Access Compliance Report

Public Rights-of-Way

(Curb Ramps)

Intersection ID: 13045	Main Street: HAMORTON_PL	Cross Street: NANDINA_ST	Location: NE
ADA ID: EDDD162FAC27	Ramp Type: BlendTrans2	Initial Pass/Fail: Fail	Overall Compliance: No
Severity Score: 1.25			
Codes/Mitigation Info/Possible Solution		Field Measurements/Component Compliance

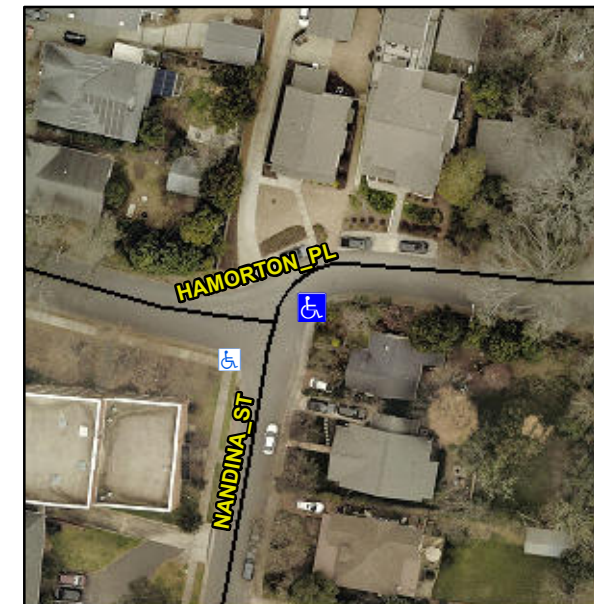
VEGETATION OVERGROWTH

PROW/ADA:

R304.5.3

Compliance	Description	Data	Compliance	Description	Data
N/A	Ramp Length (in)	55.0	Yes	BlendTrans Slope (%)	3.1
Yes	Ramp Width (in)	48.0	No	BlendTrans XSlope (%)	4.8
N/A	Flare Type LT	None	N/A	Flare Type RT	None
N/A	Flare Slope LT (%)	N/A	N/A	Flare Slope RT (%)	N/A
N/A	Flare Traversable LT?	N/A	N/A	Flare Traversable RT?	N/A
N/A	Landing Length (in)	N/A	N/A	DWS Provided?	Yes
N/A	Landing Width (in)	N/A	N/A	DWS Contrast?	Yes
N/A	Landing Slope (%)	N/A	N/A	DWS Length (in)	24.0
N/A	Landing X Slope (%)	N/A	N/A	DWS Full Width?	No
N/A	Landing Curb? (Y/N)	No	N/A	DWS Offset (in)	7.0
N/A	Shared Landing?	No			
N/A	Gutter Ponding?	No	N/A	Gutter Slope (%)	1.8
N/A	Gutter Lip Ht (in)	0.0	N/A	Gutter X Slope (%)	5.7
N/A	Painted X Walk1?	No	N/A	Painted X Walk2?	N/A
	X Walk 1 Direction	To NW		X Walk 2 Direction	N/A
	X Walk 1 Width (in)	N/A		X Walk 2 Width (in)	N/A
	X Walk 1 Slope (%)	8.1		X Walk 2 Slope (%)	N/A
	X Walk 1 X Slope (%)	6.5		X Walk 2 X Slope (%)	N/A

Possible Solutions:

Remove & Replace Curb Ramp With Two New Directional Ramps or Equivalent.
